# ADDENDUM No. 1

ITB No. 4576

## Larcom Chiller Replacement Project

Drawing E-3 is revised as part of this Addendum

E-3

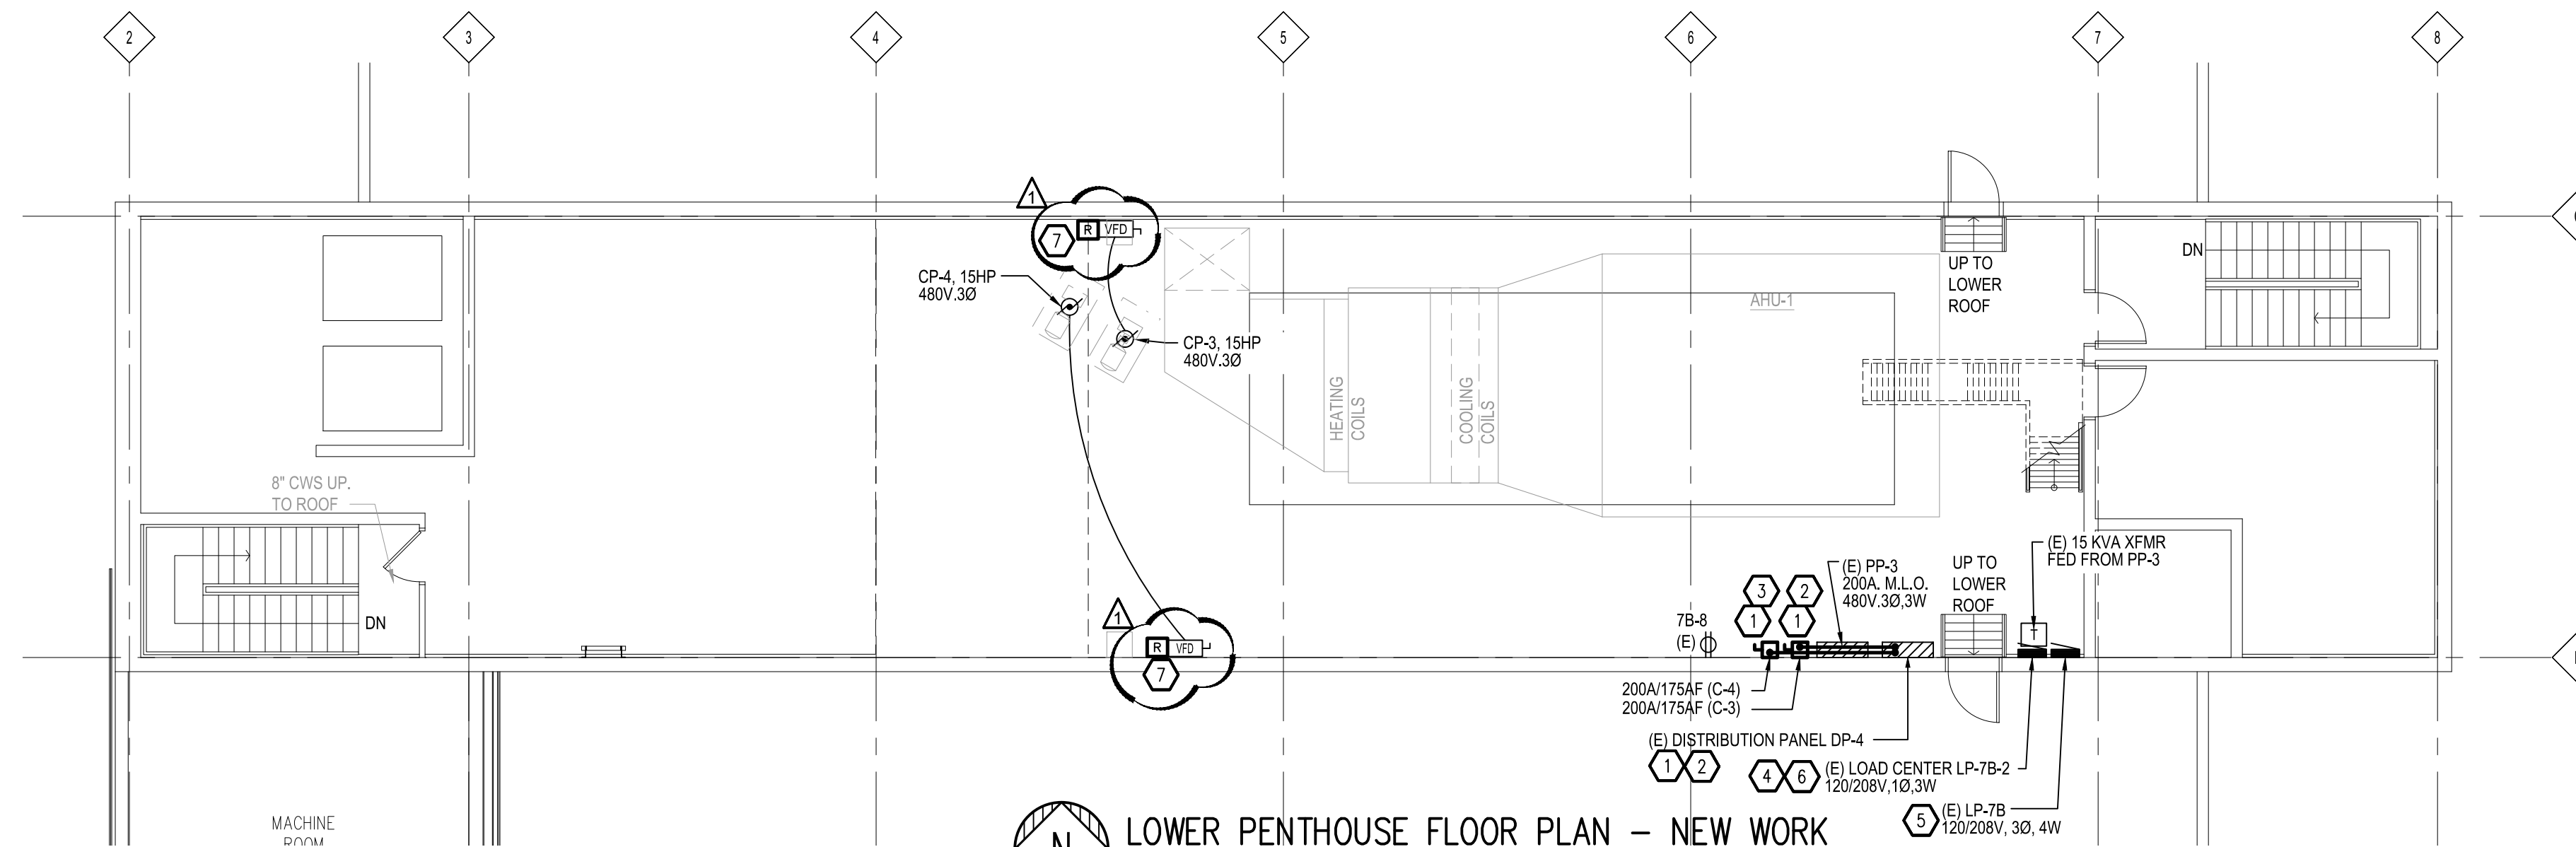
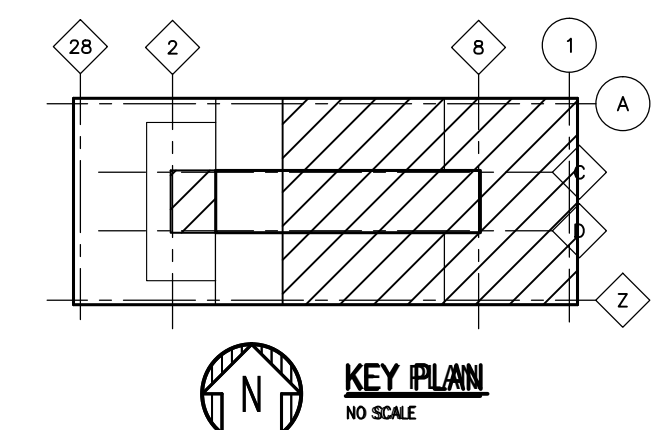
1. Refer to Drawing Sheet E-3 (Re-Issued):

a. Added New Work Key Note 7 as follows:

- “(7) Furnish, Install, and Connect 3% (1.2 mH, 480V, 3Ø) input line reactors for Chilled Water Pumps CP-3 and CP-4 Yaskawa Model CIMR-ZU4A0021FFA-166 Variable Speed Drives. Reactors shall have NEMA 1

enclosures and shall be Yaskawa or MTE RL-02512 with Cab-13V enclosure.”

- FURNISH, INSTALL, AND CONNECT 3" (1.2 MM, 480V, 3Ø) INPUT LINE REACTORS FOR CHILLED WATER PUMPS CP-3 AND CP-4 YASKAWA MODEL CIMR-ZU40021FFA-166 VARIABLE SPEED DRIVES. REACTORS SHALL HAVE NEMA 1 ENCLOSURES AND SHALL BE YASKAWA OR MTE RL-02512 WITH CAB-13V ENCLOSURES.
